## SLG46620-EV Errata Note

This document contains the known errata for SLG46620-EV and the recommended workarounds.

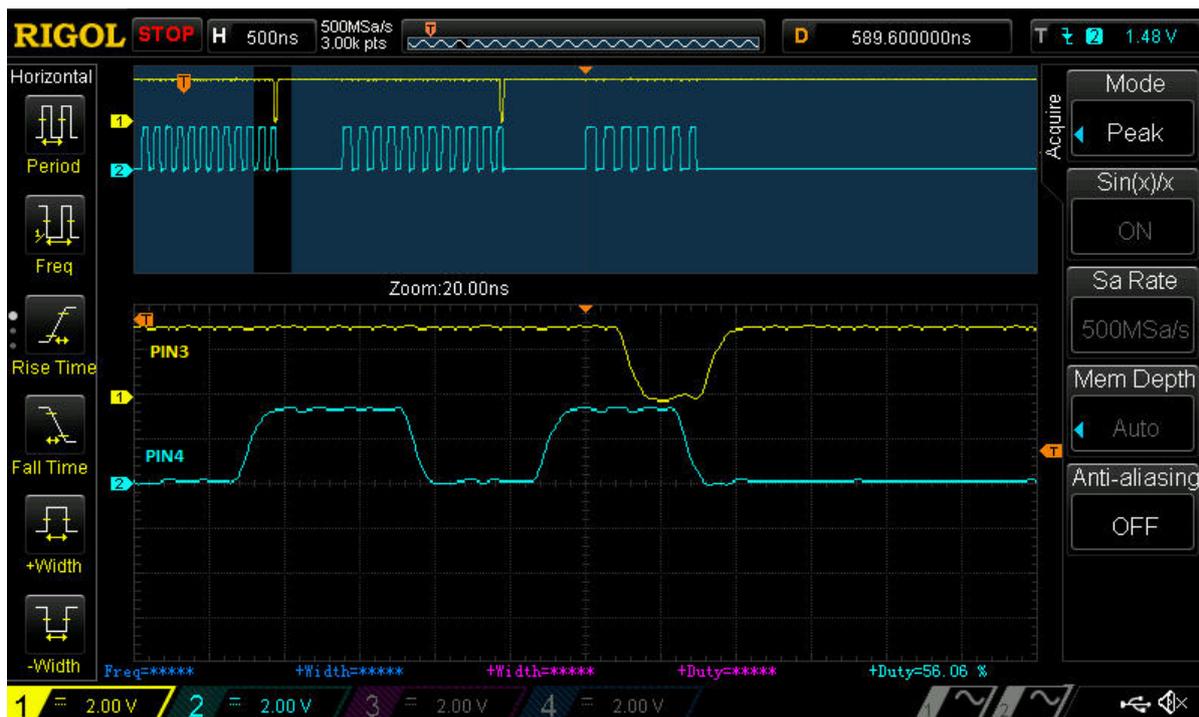
The output of the ACMP incorrectly goes low even when IN+ is greater than IN- if the RING OSC is active when the WS signal rises.

Channel 1 – ACMP out

Channel 2 – WS\_OUT

Avoid using the RING OSC with the WS Controller, or add a filtering block on the ACMP output to filter out the glitch.

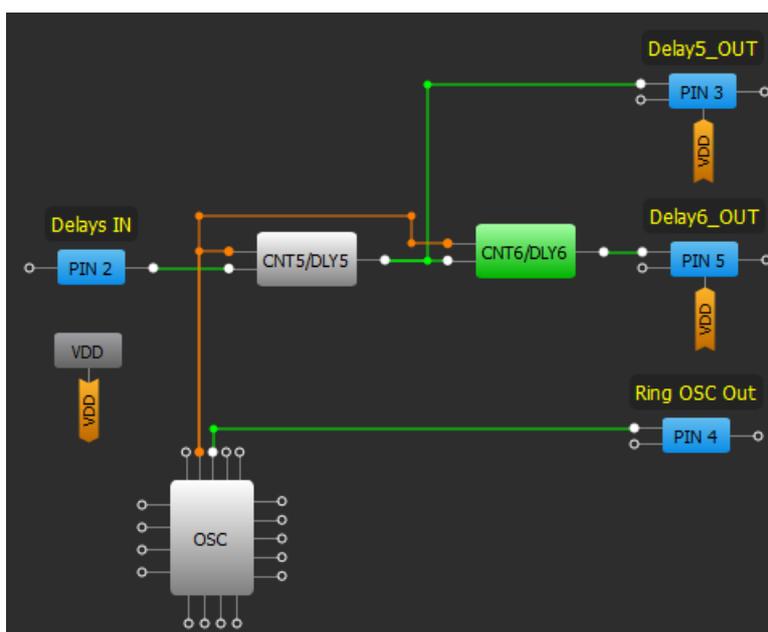
Channel 1 – 2-bit LUT0 output; Channel 2 – Ring OSC output

Such behavior will lead to substantial error in period calculations if the delay time is relatively small.

A similar situation can occur while using two connected delays (all edge detect types except for a pair “Rising edge DLY – Falling edge DLY”).

In the following example, Delay5 and Delay6 are configured in the same way. However, Delay5 time is 11.4us instead of expected 0.4us (Delay5 time).

- Set Ring OSC power mode to “Force Power On”
- or, Set Turn on by register option in BG (Band Gap) block as “Enable”

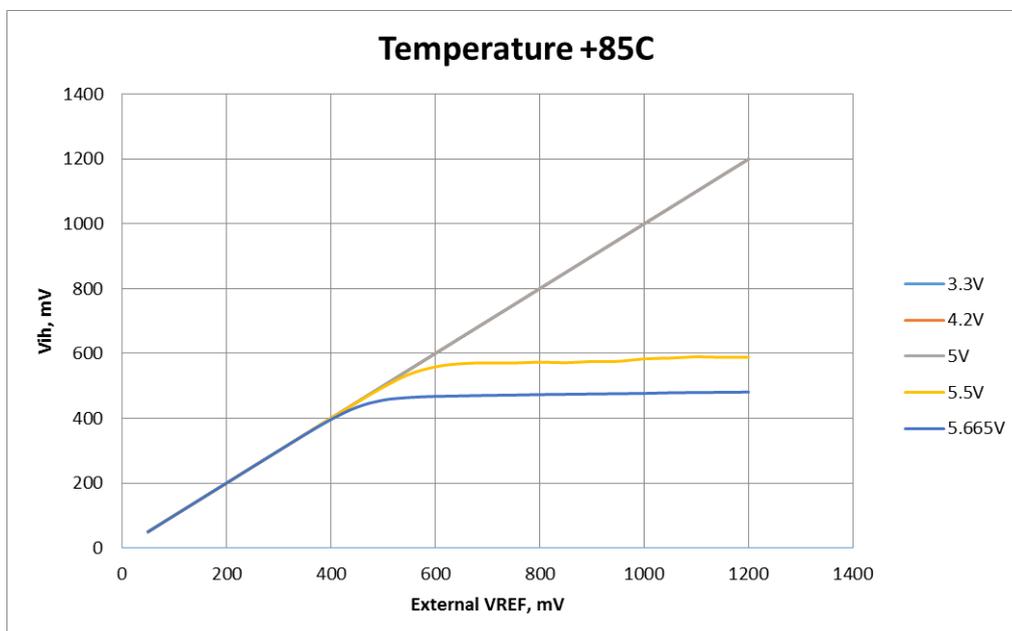
The PGA block has an offset when its output through the VREF is loaded. For reference, the table below shows the load vs PGA 4x gain.

When the load current is higher than 10 mA the output offset is large and may influence the design operation significantly.

Use an external buffer to support high load.

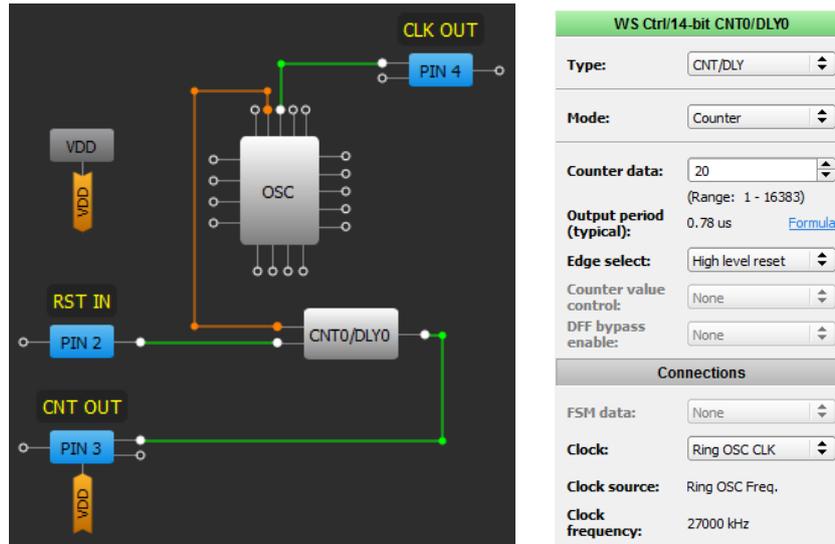
When using external Vref source, the ACMP comparison may happen at wrong threshold if the external Vref voltage is higher than a particular value (please see figure below) at high VDD values (> 5V) and high temperature.

Avoid using ACMPs in such conditions.

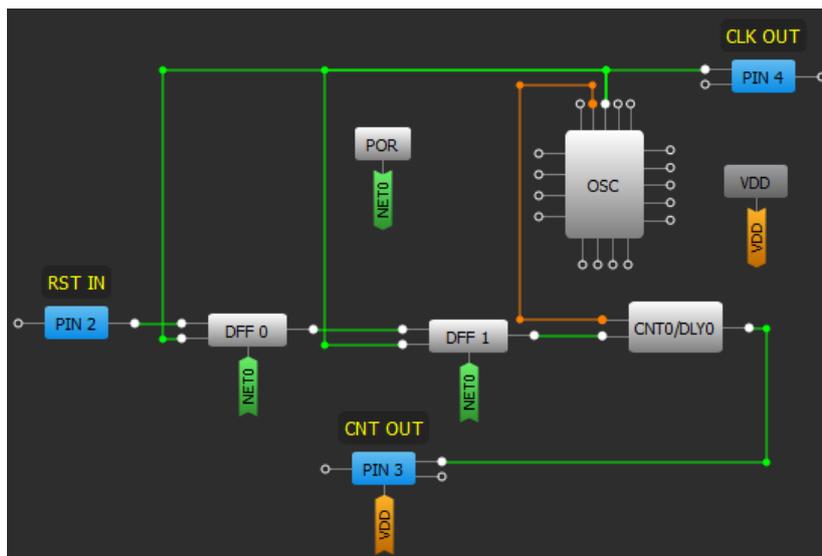
If the Counter Reset occurs at a time very close to a rising edge of the clock signal during clock signal generation (for example OSC operation), there is a possibility that the Counter Data of the Counter is reset incorrectly and the counter end signal (HIGH pulse) may appear faster than expected. This phenomena appears more frequently the higher the clock frequency is.

Synchronize RESET input of the Counter with its CLK using 2 DFF cells as shown in the image below.

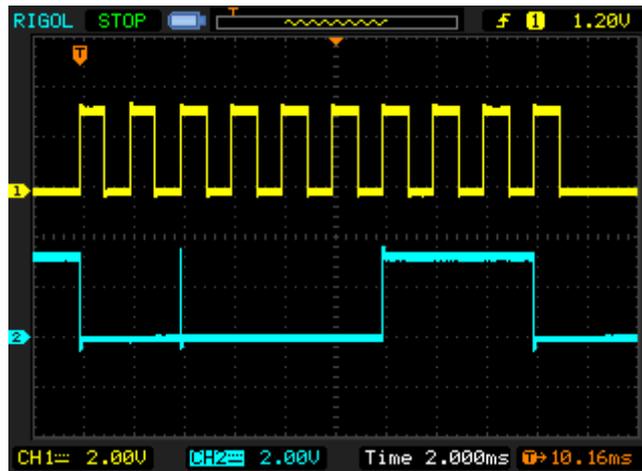
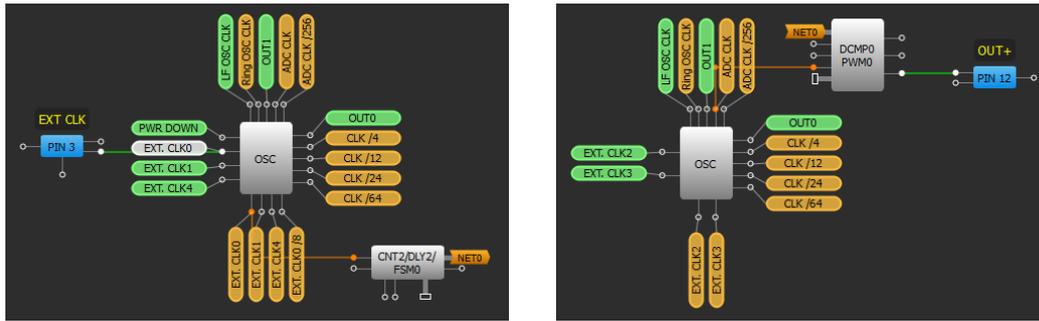
DCMP's OUT+ output may have a glitch when the input data is changed. This issue appears more frequently the higher DCMP clock is.

For example, DCMP IN+ sources from FSM0 and IN- from Register0. DCMP is clocked from the Ring OSC.
